## SUMMARY OF CONCERNS IN RELATION TO THE PROPOSED NORTHCONNEX TUNNEL

**This is an objection to many aspects of the proposed NorthConnex tunnel.**

## SECTION A: THE CONNECTIVITY OF NORTHCONNEX SOUTHERN VENTILATION FACILITY AT THE SOUTHERN INTERCHANGE, THE SOUTHBOUND TUNNEL IN PARTICULAR

MOTORWAY OPERATIONS COMPLEX - SOUTHERN VENTILATION FACILITY - SECTIONS  
M1-M2-5000-DR-JD-0525

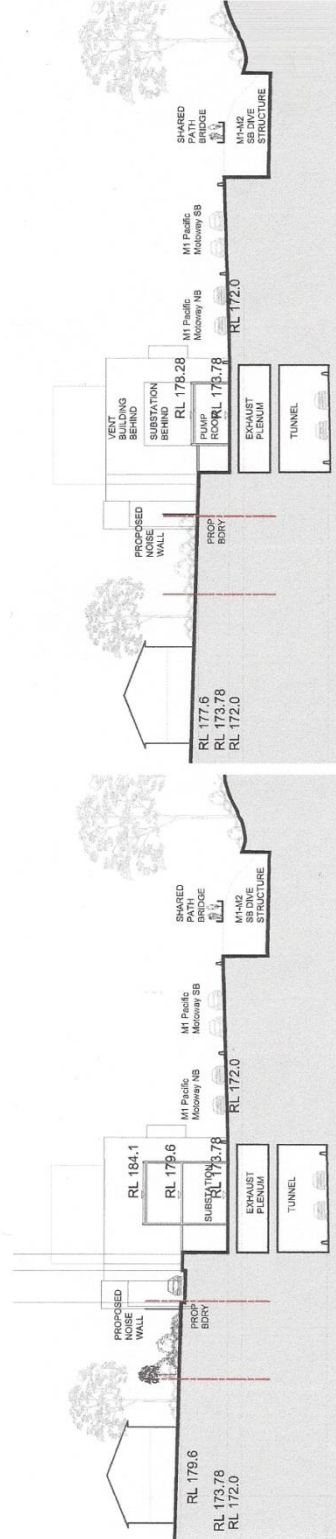
6. *EIS Volume 4, Technical working papers Urban Design, 8.0 Landscape Design*  
EIS Page 176 is the diagram "Motorway Operations Complex – Southern Ventilation Facility – Site 1-1". *Page 13 below* The diagram does not show any connection to either the northbound or southbound tunnel. In the same Landscape Design section, EIS Page 182 is the diagram "Wilson Road Tunnel Support Facility –Section" *Page 14 below* which clearly shows the connection to the tunnels. In the same Landscape Design section, EIS Page 189 is the diagram "Northern Ventilation Facility – Landscape Concept Section". *Page 15 below* This also clearly shows the connection to the tunnels.

CONNECTION TO TUNNEL  
TBC

- Diagrams need to be provided showing the inter-relation between the shaft, the ventilation outlet and the motorway operations centre with a clear description of what is to be constructed and how it will operate.
- The community needs irrefutable evidence that the polluted air from the southbound tunnel exit portals will not be allowed to flow like an invisible sewer through West Pennant Hills, North Rocks, Carlingford and Beecroft.

M1-M2-5000-DR-UD-0550  
NORTHERN VENTILATION FACILITY - CROSS SECTIONS

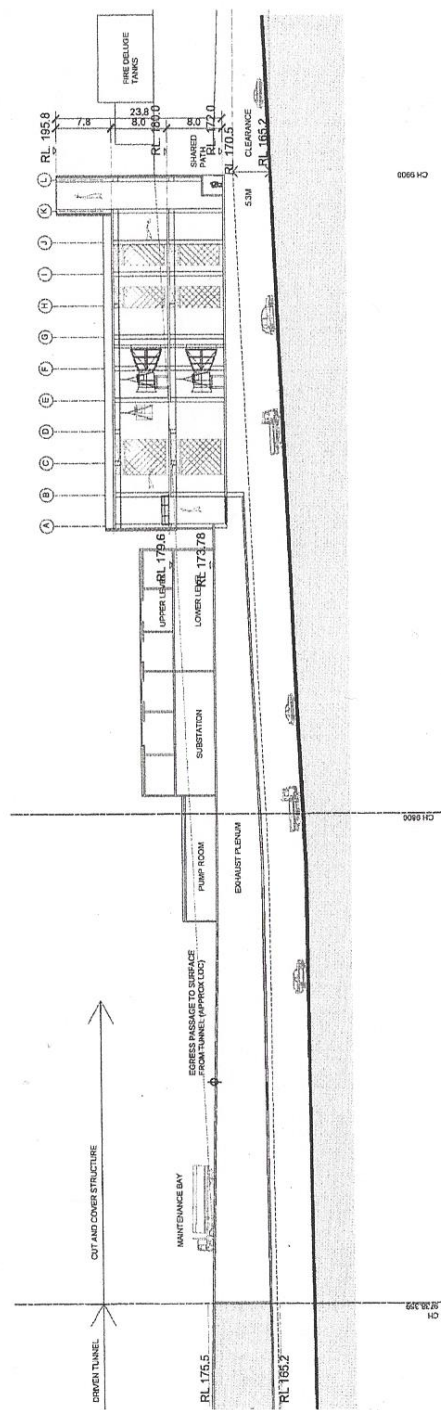
EIS page 135 *Page 11 below* there is a very explicit diagram showing the *Northern Ventilation Facility – cross section*.

EIS page 134 *Page 12 below* there is a very explicit diagram showing the *Northern Ventilation Facility – long section*.
